Performance Monitoring Plan

Wagner Road Extraction

December 22, 2005

Pall Life Sciences
Scioto Twp., Washtenaw County, Michigan
Wagner Road
Performance Monitoring Plan

MONITORING WELL LOCATIONS

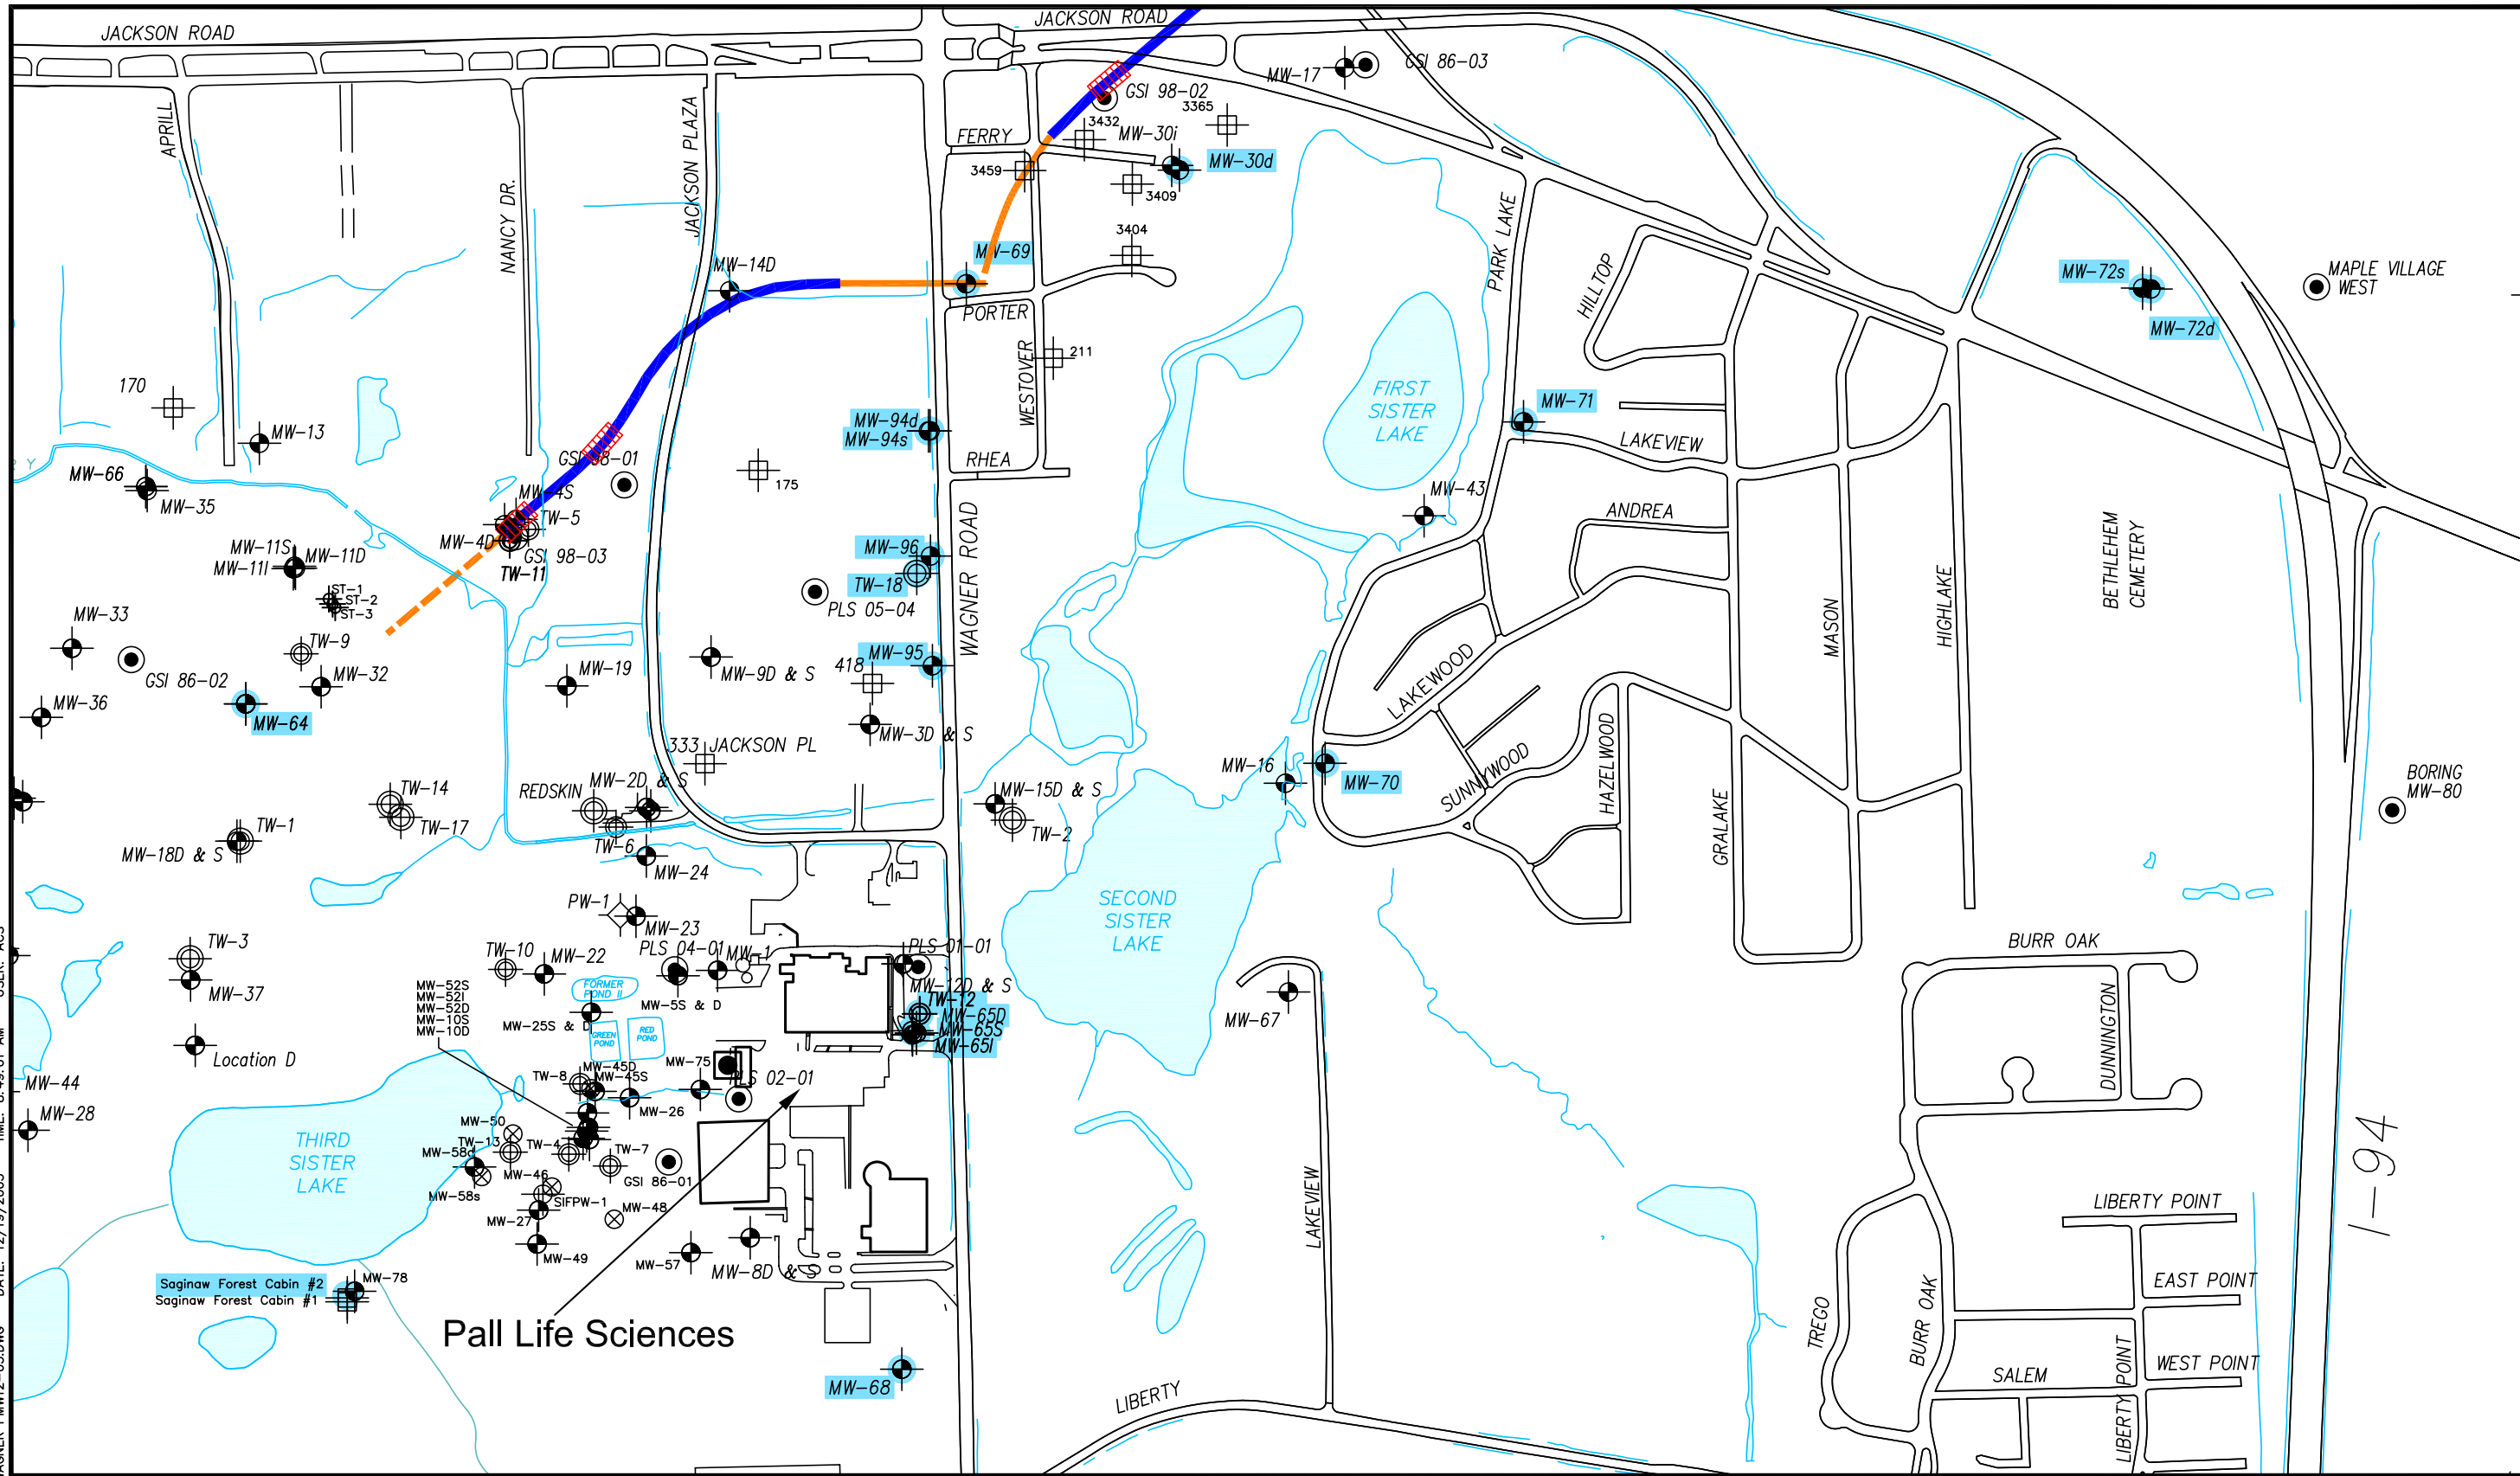
PLS proposes to install one or more wells at two locations. One well, positioned east/northwest of TW-18, will be installed as a performance monitoring well. A second well, south of TW-18, will be installed to further investigate the extent of 1,4-dioxane south of TW-18. . Proposed areas for the installation of these wells are shown on Attachment 2 and are described below.

MDEQ has questioned PLSs interpretation of the southern boundary of the Unit E plume, specifically the area between TW-18 and TW-12. PLS has proposed to investigate this area to further the understanding of the Unit E plume in this area.

Potential locations for wells in the area east of TW-18 are severely limited due to difficult access (Dolph Park), heavy vegetation, and a complex wetland/marsh system. Due to access limitations, it is necessary to install a well closer to TW-18 than ideal. Since this area is likely to be within the capture of TW-18, water quality data from this well site would be unlikely to provide a good indication of the performance of TW-18. However, if the well were to be installed further north/northeast, then water quality data from this well cannot be used to assess the intended objectives of the Wagner Road system. This is because operation of TW-18 has the potential to pull some water from the Unit D2 plume toward the well from the north. As such, it will be extremely difficult to determine if a well positioned north/northeast of TW-18 would be monitoring the Unit E plume or the Unit D2 plume to the north.

PLS is proposing the installation of a well(s) in the area shown on Attachment 2. Data from this boring/well(s) will be used to assess conditions in this area and to evaluate the potential need for adjustments to the purge system.
